# REGIONAL REVIEW NOTIFICATION

**ARC REVIEW CODE:** R1909051

**Name of Proposal:** Quarry Yards (DRI 2993)

**QUARRY YARDS DRI 2993**  
**City of Atlanta**  
**ARC Natural Resources Group Review Comments**

TITLE: DRI SITE PLAN

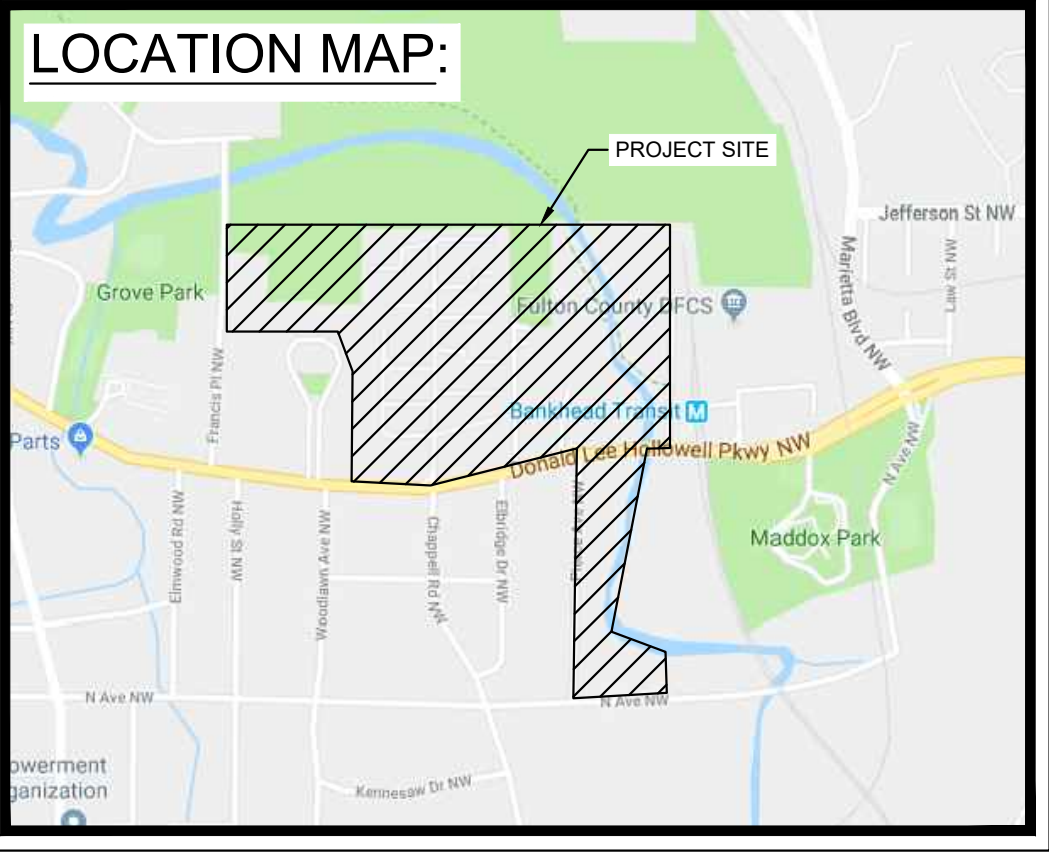
Additional preliminary ARC staff comments focused on water resources planning are attached to this report. Of note is the fact that the City 50-foot undisturbed stream buffer and additional 25-foot impervious

setback (for a total depth of 75 feet), as well as the 25-foot State Sediment and Erosion Control Buffer, are not shown on either side of Proctor Creek south of D.L. Hollowell Parkway (the buffers are shown on the north side of the Parkway). Additionally, two new multifamily residential structures are shown near Proctor Creek south of the Parkway. If these structures intrude into the City stream buffers, variances may be necessary.

The submitted site plan and the USGS coverage for the project area both show Proctor Creek running roughly south to north across the eastern side of the property. No other blue-line streams are shown on or near the project property on any coverage. The City 50-foot undisturbed stream buffer and additional 25-foot impervious setback (total depth of 75 feet) as well as the 25-foot State Sediment and Erosion Control Buffer are shown on both sides of Proctor Creek north of Donald Lee Hollowell Parkway, but not south of the road. The site plans show two proposed structures north of the Parkway intruding into the impervious setback and a pathway running along and crossing the creek. However, based on aerial photo evidence, the path already exists, and the proposed structures are on the sites of existing structures. Two new structures are shown near Proctor Creek south of the Parkway. If these structures intrude into the City stream buffers, variances may be necessary.

No other streams or other waters of the State are shown on the submitted site plan or on the USGS coverage. Any other State waters identified on the property will be subject to the State 25-foot Sediment and Erosion Control buffer. The City and State buffers should be shown on the portions of Proctor Creek on the project property south of Donald Lee Hollowell Parkway.
